Groundwater Application Review Summary Form

Application # G- 19426

GW Reviewer Steve Ahlquist Date Review Completed: 11/27/2024

A. GENERAL INFORMATION: Applicant's Name: Kraemer Farms LLC County: Marion

Well Statistics for T6S R1E Secs 19,20,21,27,28,29

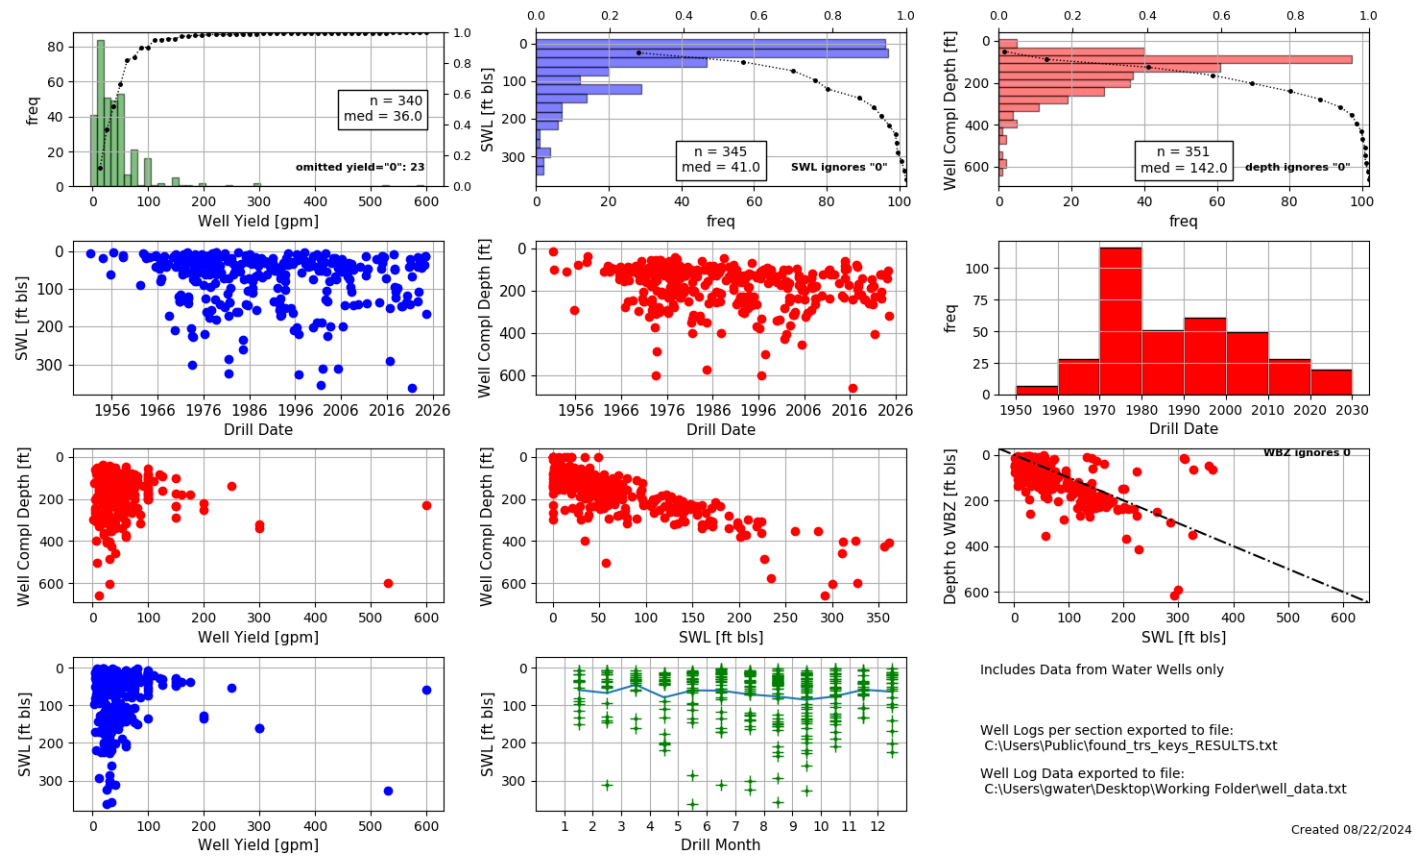
Nearby well records indicate a median reported yield of 36 gpm and a maximum reported yield of 600 gpm (see attached Well Statistics). The well log for MARI 17225 (proposed POA Well 1) indicates a well yield of 45 gpm. The proposed rate of 0.65 cfs (292 gpm) is in the upper range of reported yields for the area and may be achievable but will likely require multiple wells.

Water-Level Measurements in Nearby Wells

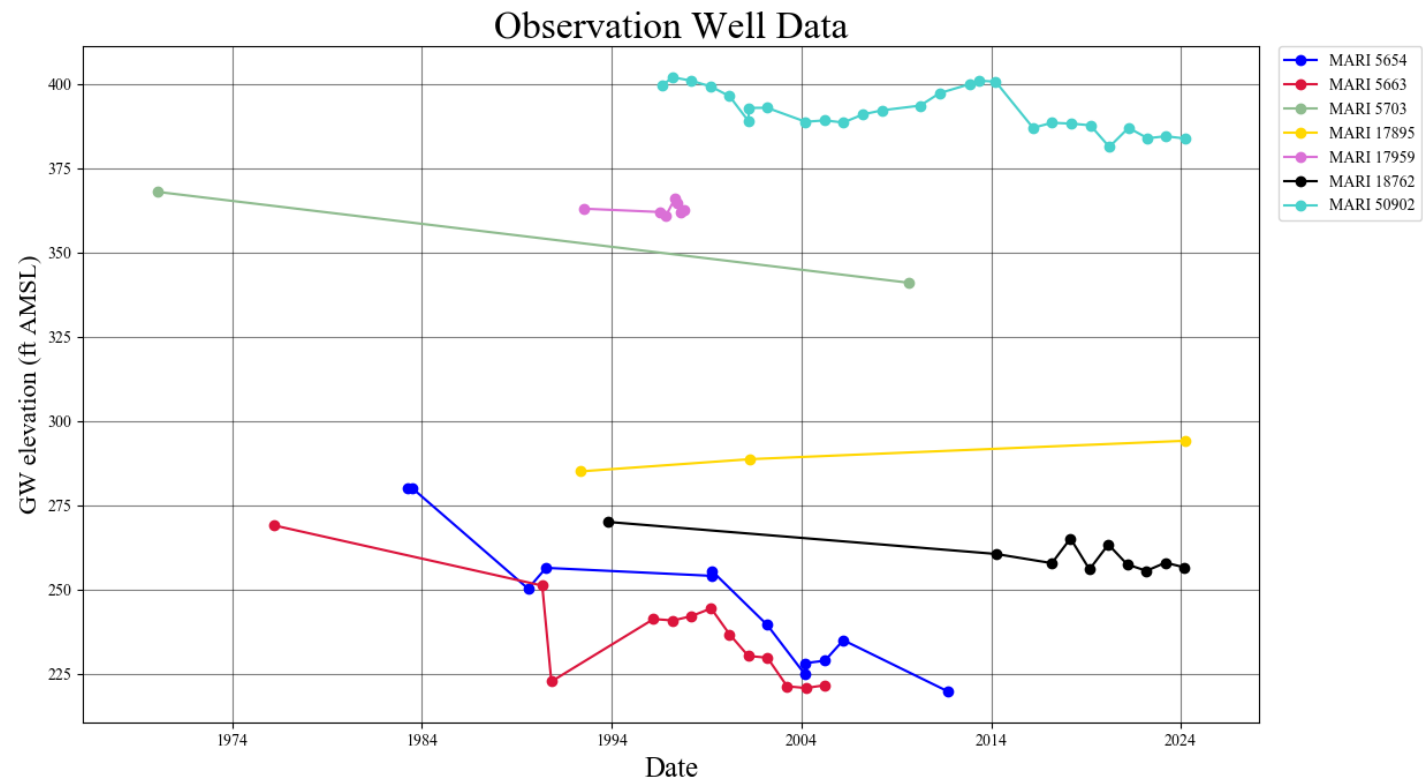
Groundwater level data in this area (within 1.5 miles) is limited to 7 wells that obtain water from the CRBG aquifer. Hydrographs for these wells indicate that water levels are declining (see attached Water-Level Measurements in Nearby Wells). Permits issued for nearby POAs which obtain water from a CRBG aquifer contain the standard condition requiring curtailment of pumping when water levels have declined 15 ft or more; any permit pursuant to this application would be conditioned similarly. MARI 50902 is the closest well with a long-term water level record and likely obtains water from the

same WBZ as the proposed POAs. Water levels in MARI 50902 have declined more than 18 feet between March 1997 and March 2024. Water level records for several other wells in the area (e.g. MARI 5654, MARI 5663, MARI 18762) show declines that are approaching or are greater than 15 ft. The proposed use would contribute to declines and would result in permit conditions being triggered on new and existing water rights and subsequent regulation. **This would preclude the perpetual use of the aquifer so the proposed use will not likely be available within the capacity of the resource.**
